Model: Cor-C1 / Cor-C1_SOP	Date: 05-Sep-14	No.: RD197002d
-----------------------------------	-----------------	----------------

Subject: Firmware Release Note: browser		Prepared by: H. Morishima	
From: 2nd Tech Service Sect., MFP/Printer Tech Service Dept.			
Classification:	<input type="checkbox"/> Troubleshooting <input type="checkbox"/> Mechanical <input type="checkbox"/> Paper path <input type="checkbox"/> Product Safety	<input type="checkbox"/> Part information <input type="checkbox"/> Electrical <input type="checkbox"/> Transmit/receive <input checked="" type="checkbox"/> Other (Firmware)	<input type="checkbox"/> Action required <input type="checkbox"/> Service manual revision <input type="checkbox"/> Retrofit information <input checked="" type="checkbox"/> Tier 2

This RTB has been issued to announce the firmware release information for the **browser**.

Pic. 1-2

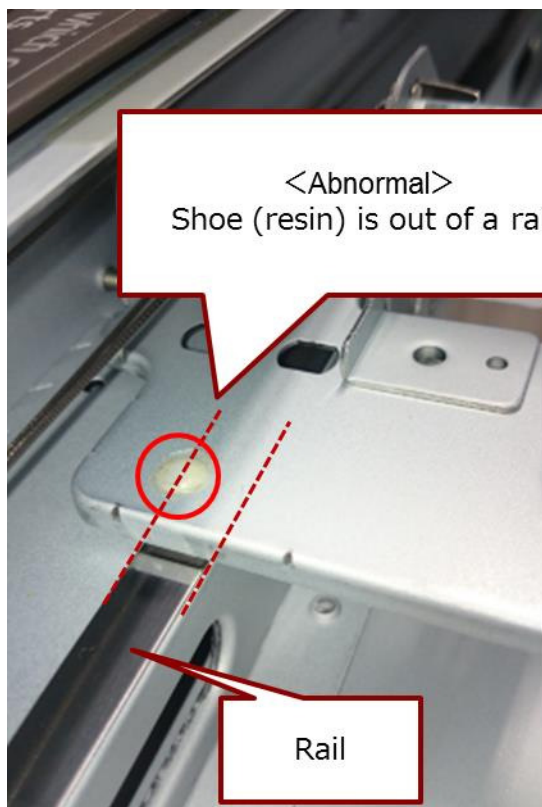
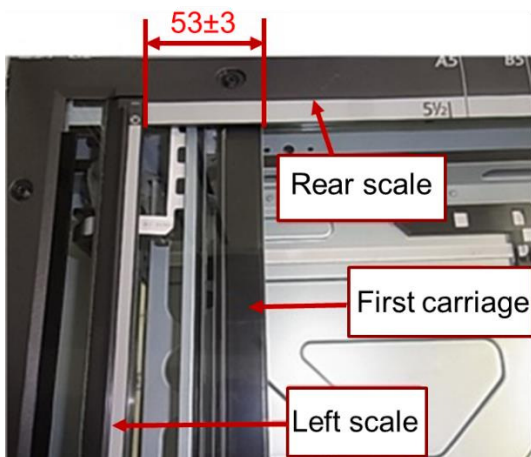
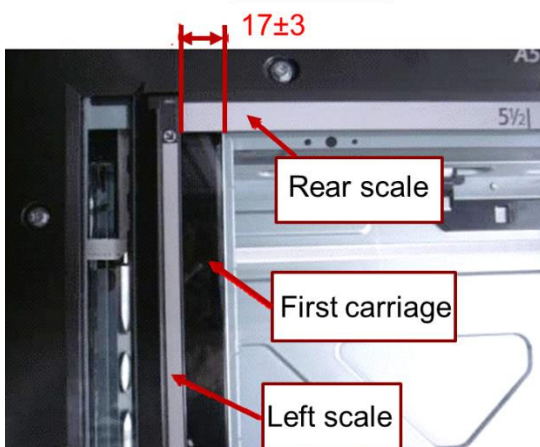
The shoe (resin part circled in red) on the second scanner carriage disengages from the rail, due to shock and/or shaking during machine transport.

Before shipment, the first carriage will be moved to the new position shown below (the distance from the left scale to the edge of the carriage was decreased from $53 \pm 3\text{mm}$ to $17 \pm 3\text{mm}$).

The shape of the second carriage will be changed so that it does not disengage from the rail.

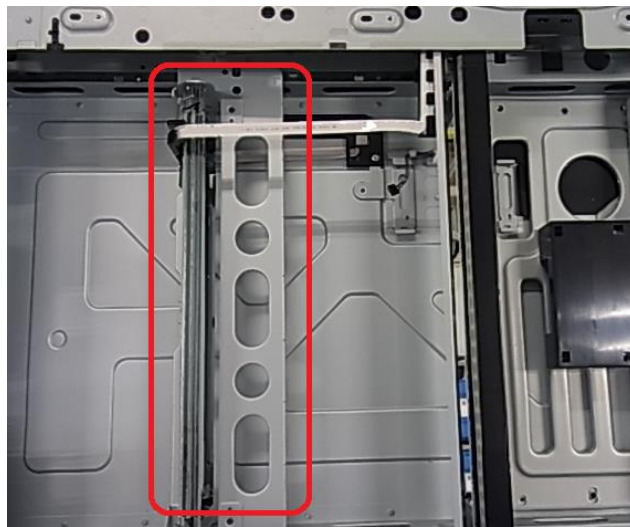
4. Carefully lift up the second scanner carriage, and then put the shoe back into the rail.

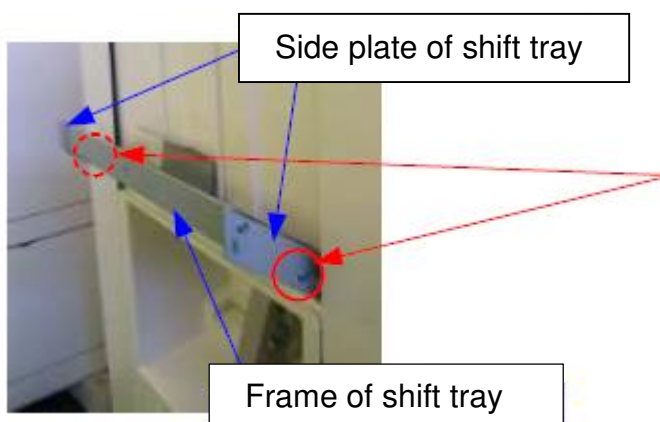
Attach the sheet (P/N: D6833644) between the frame and the side plate in the areas circled.

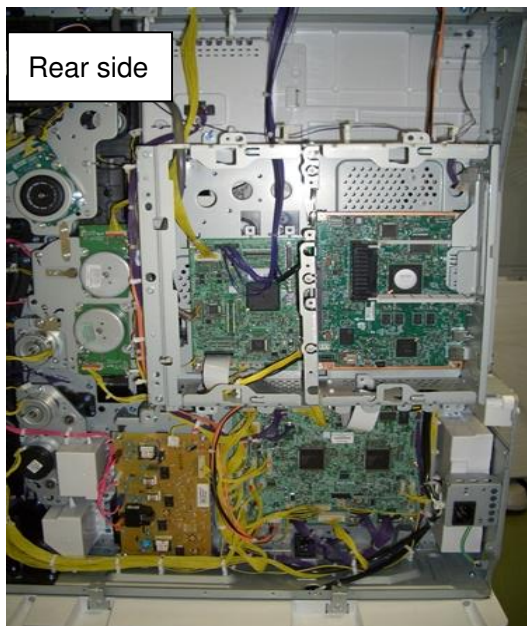
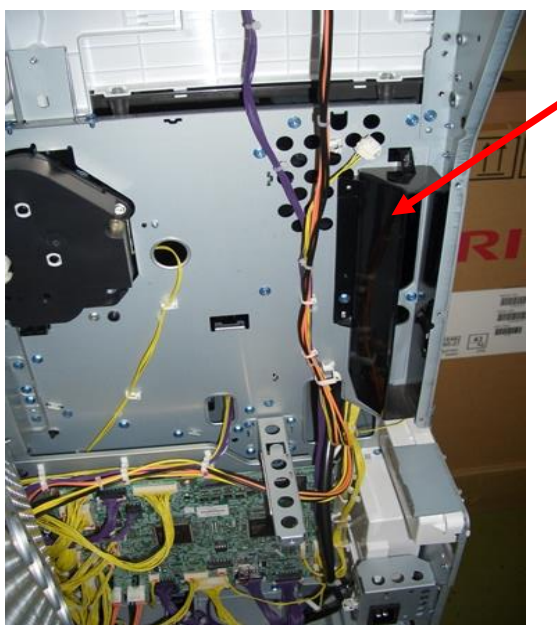
The relay harness was mistakenly routed between the air duct and the frame on the production line.

8. Check whether or not the relay harness (circled in red) is caught between the air duct and frame.

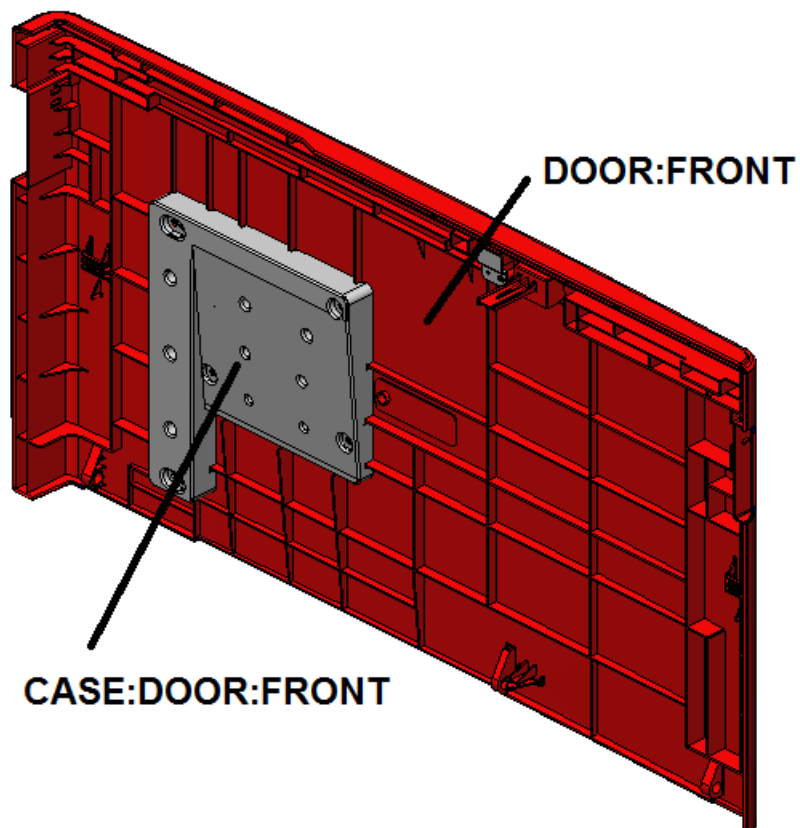
Old part number	New part number	Description	Q'ty	Int	Page	Index	Note
D2021242	D2011242	DOOR:FRONT	1-1	X/X	-	-	Set as O/O
D2021241	D2011241	CASE:DOOR:FRONT	1-1	X/X	-	-

Note: When replacing the front door, replace the front door case also at the same time.

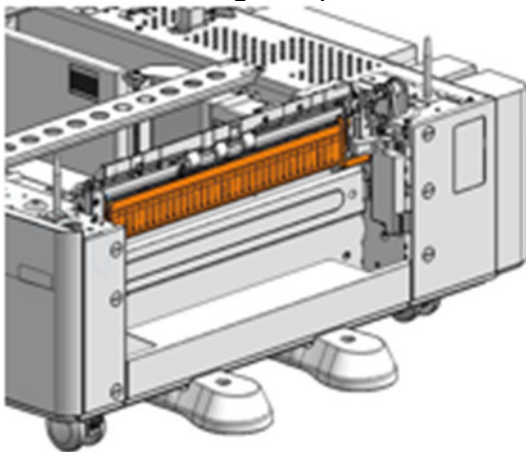
Change: Added cushions and changed the shape of the guide plate.

Reason: To further strengthen and prevent breaking of the guide plate.
